REMARKS

AMENDMENTS TO THE DRAWINGS

The attached sheets of drawings include changes to Figures 4, 7, 8, and 9.

Fig. 4

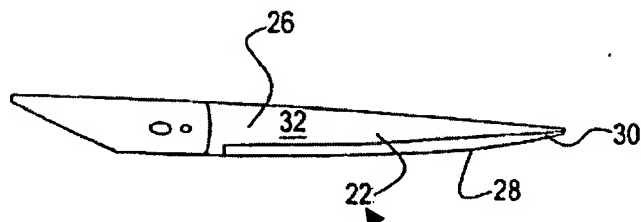
Page 9, which includes Figures 3 and 4, replaces the original sheet including Figures 3 and 4. Only Figure 4 on this sheet has been amended, to delete reference numeral 22 as instructed by the Examiner in the Office Action (“In Fig.4, reference numeral “22” should be deleted.”).

Reference numeral 22 deleted

Fig. 7

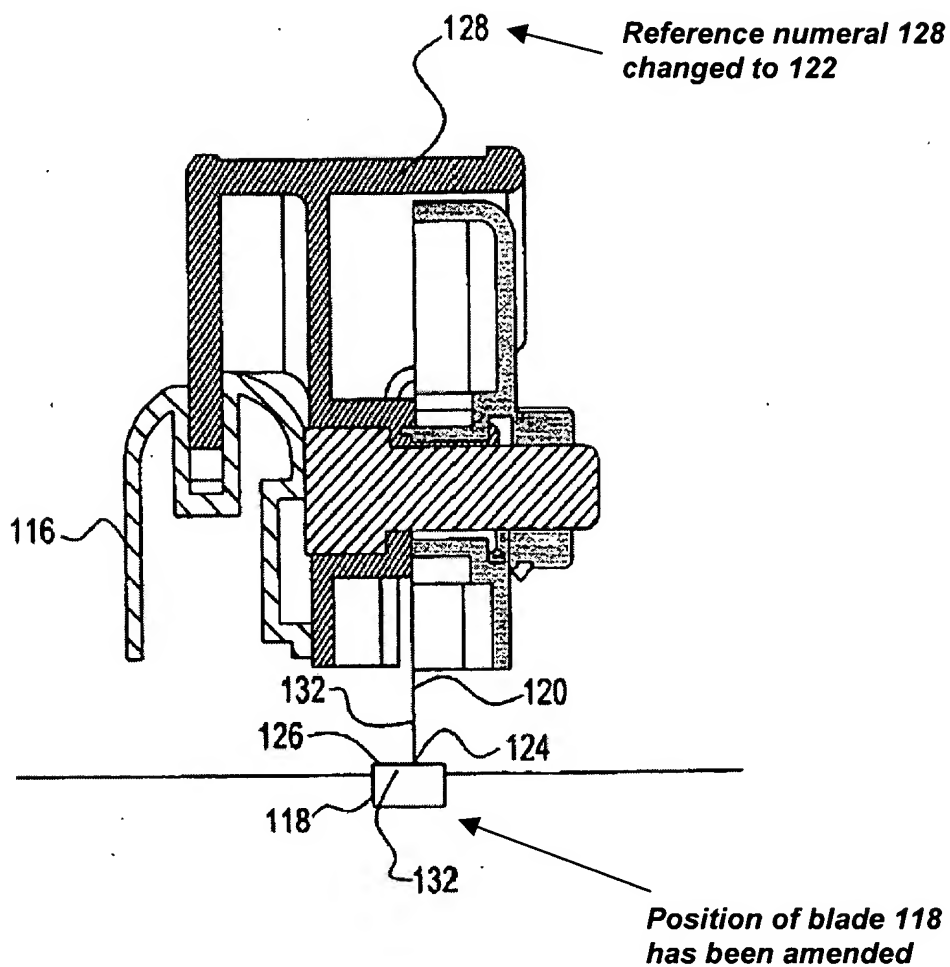
Page 11, which includes Figure 7, replaces the original sheet including Figure 7. In amended Figure 7, reference numeral 128 (paper) has been changed to 122 (housing), in response to the Examiner’s objection that “In Fig.7, reference numeral “128” should read -- 122 --.” Also in Figure 7, the drawing has been amended to more accurately depict the position of blade 118 as described in the specification in paragraphs [0052] and [0053].

Fig. 8

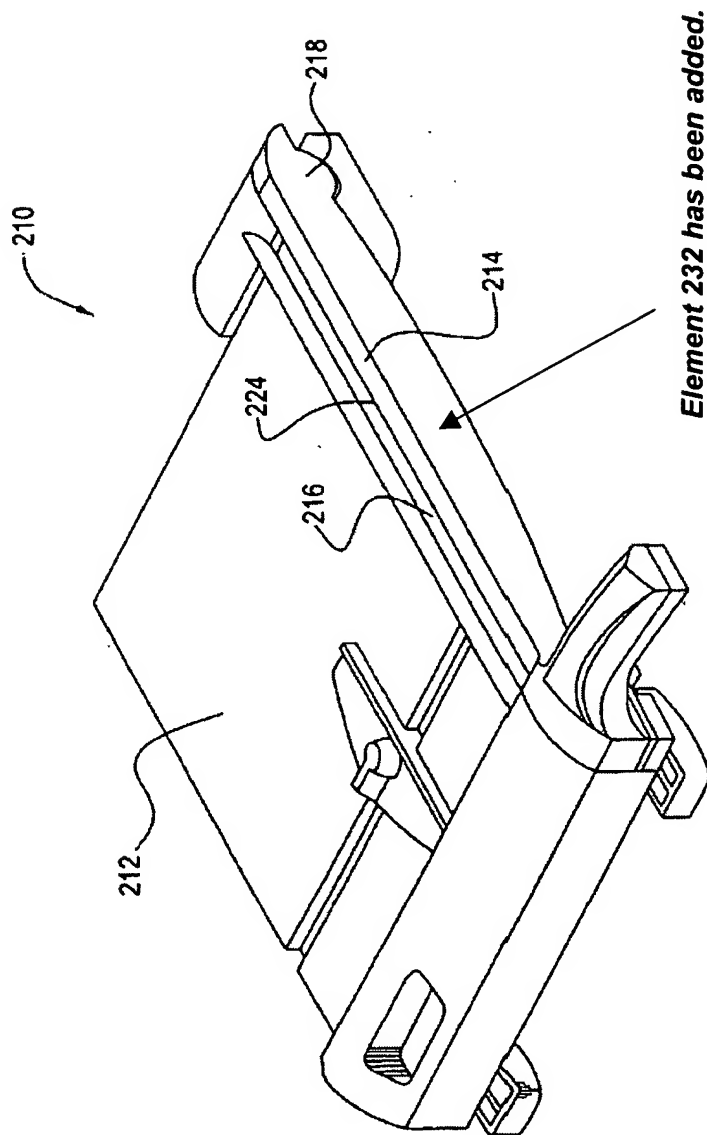
Pages 13 and 15, which include Figures 8 and 9, respectively, replace the original sheets including Figures 8 and 9. Figures 8 and 9 have been amended to include reference numeral 232, in response to the Examiner’s objection that “On pages 11 and 12 [of the Specification], reference numeral ‘232’ is not found in any drawings.”
